COMMENTS ON THE DRAFT SITE INSPECTION PRIORITIZATION REPORT
TEXAS INSTRUMENTS INCORPORATED ATTLEBORO, MASSACHUSETTS SITE
 CERCLIS No.: MAD007325814 Draft Date: May 20, 1998
 Prepared by: Lisa White of Stone & Webster

Comments submitted by: Michael J. Elliott, Environmental Manager
 Texas Instruments Incorporated, Materials & Controls
 Comments submission date: June 17, 1998

FIGURE 2 SITE VICINITY MAP

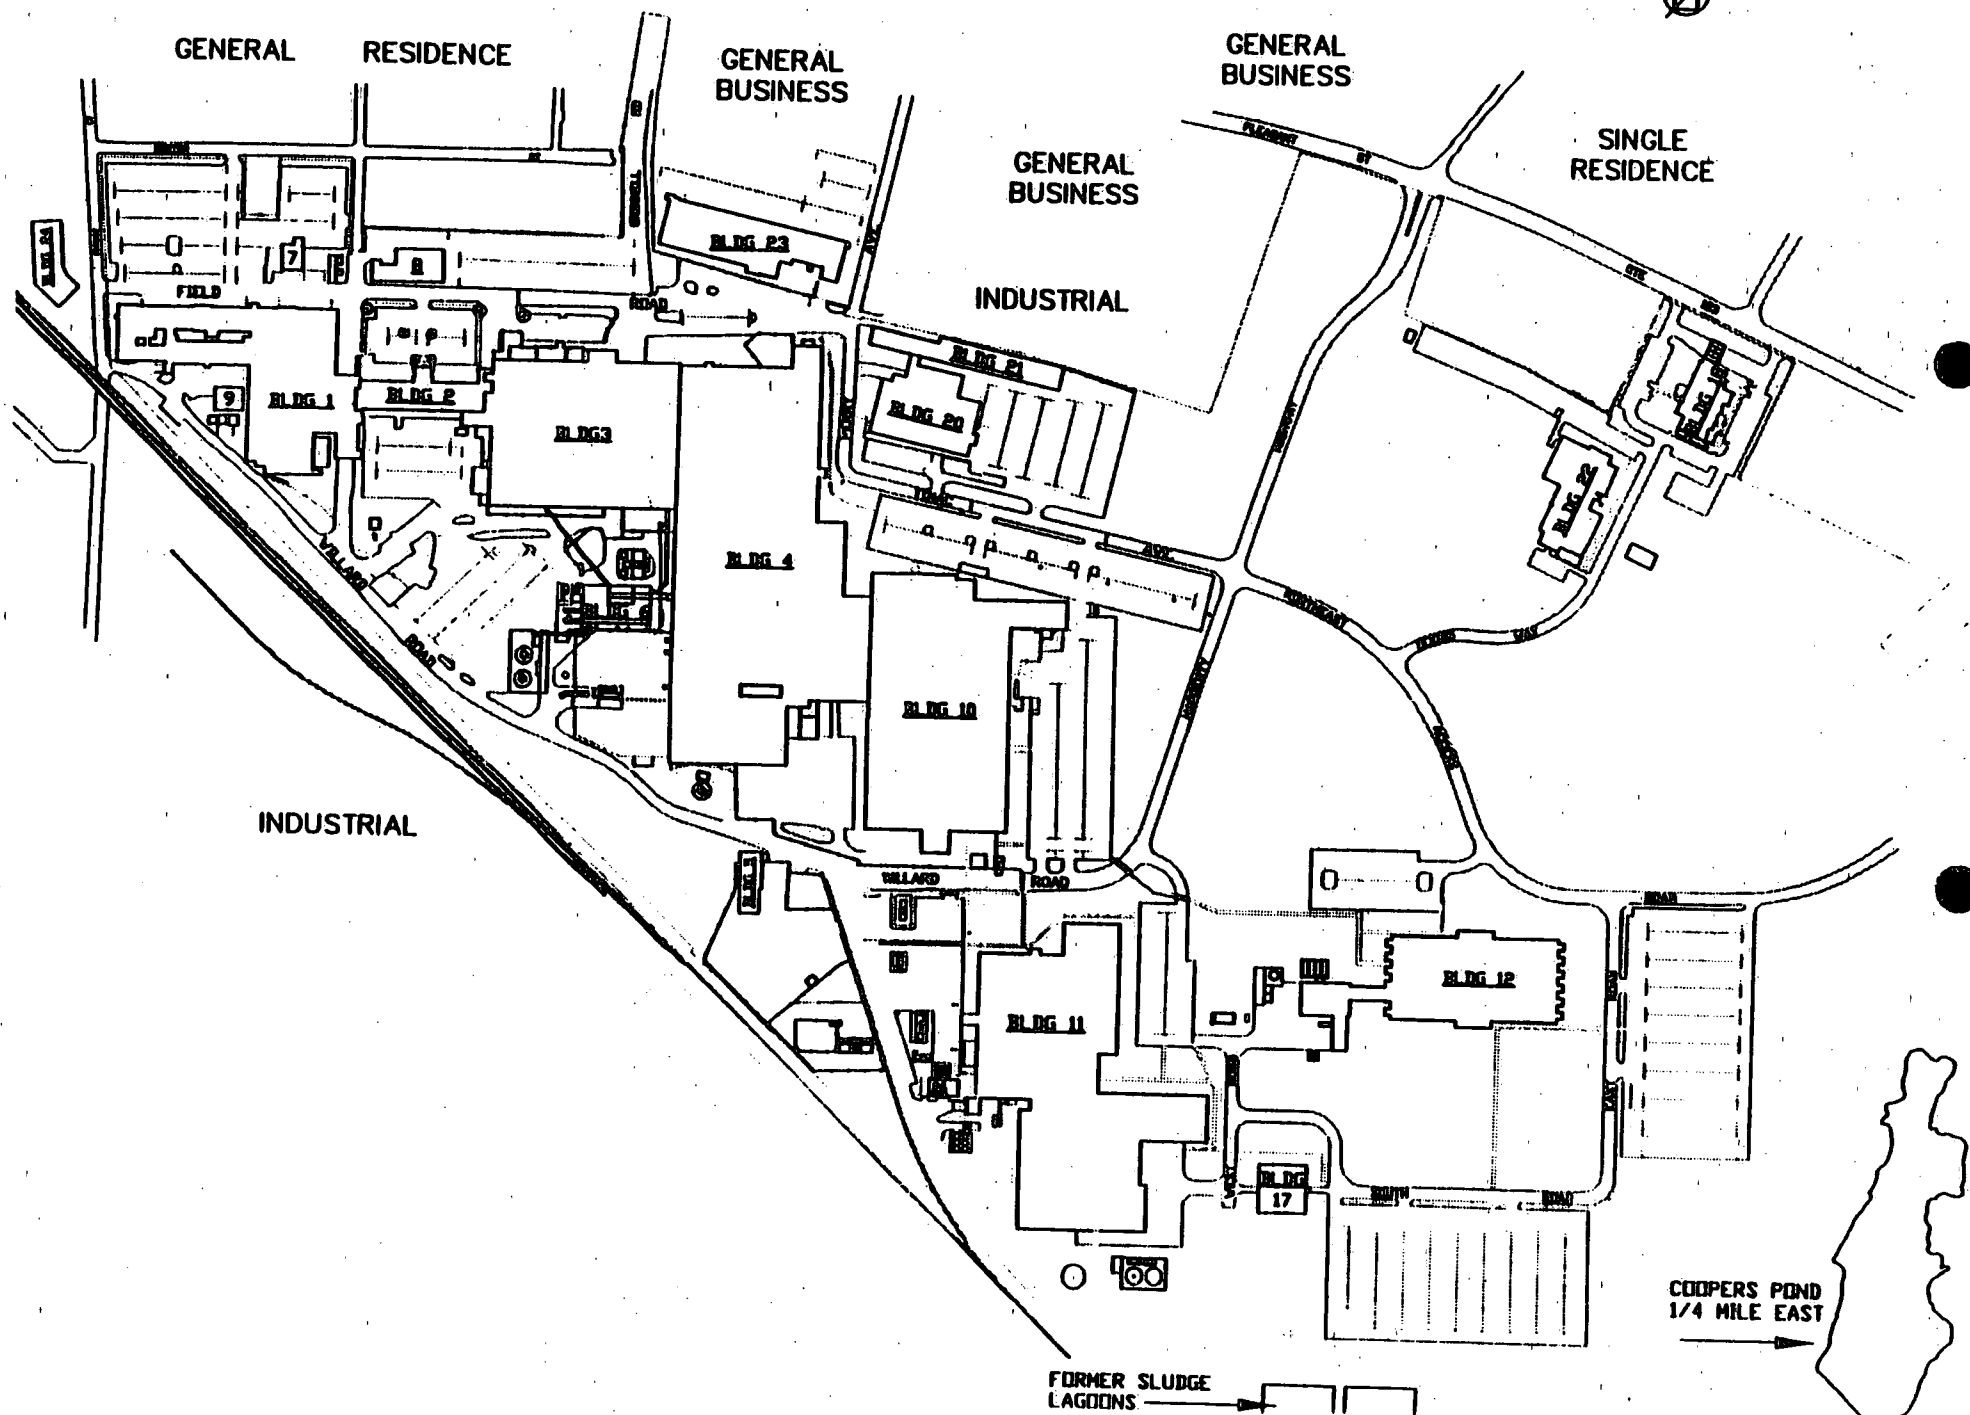
PAGE	SECTION	COMMENTS
i	Cover/Title Page	The name of Texas Instruments Incorporated is erroneously written throughout the entire report as "Texas Instruments, Inc." The legally correct version is with no comma, and with the word "Incorporated" spelled out in entirety. Lisa White acknowledged that she was familiar with the correct spelling, but that she was obligated to be consistent with the name as it appears in EPA files. Can EPA correct the file? <i>Comment will be investigated</i>
1	SITE DESCRIPTION, 1 st paragraph, 3 rd sentence	Approximately one-third of the site has been developed. <i>Comment will be incorporated into Final SIP</i>
2	SITE DESCRIPTION, Figure 1, Site Location Map	TI provided Lisa with a marked-up version of the map showing more accurate stream flow directions. <i>Comment will be incorporated into Final SIP</i>
3	SITE DESCRIPTION, Figure 2, Site Vicinity Map	TI provided Lisa with a CAD drawing, both electronic and print, containing a suggested replacement map. (See attached figures.)

4	SITE DESCRIPTION, Figure 3, Site Sketch	TI provided Lisa with a CAD drawing, both electronic and print, containing a suggested replacement map. (See attached figures.)
5	SITE DESCRIPTION, Figure 4, Site Plan with Sampling Locations	TI provided Lisa with a CAD drawing, both electronic and print, containing a suggested replacement map. (See attached figures.)
6	SITE DESCRIPTION, 2 nd full paragraph on page, 2 nd sentence	All roads are privately owned on the TI site, so TI questions the validity of the statement that "several public roads traverse the site." <i>Comment will be incorporated into Final SIP.</i>
6	SITE DESCRIPTION, 2 nd full paragraph, 3 rd sentence	Delete "north-northwest corner," replace with "eastern edge." <i>Comment will be incorporated into Final SIP.</i>
6	SITE DESCRIPTION, 3 rd full paragraph on page, 1 st sentence	Delete "semi-conductors." <i>Comment will be incorporated into Final SIP.</i>

Figures will be incorporated into text.
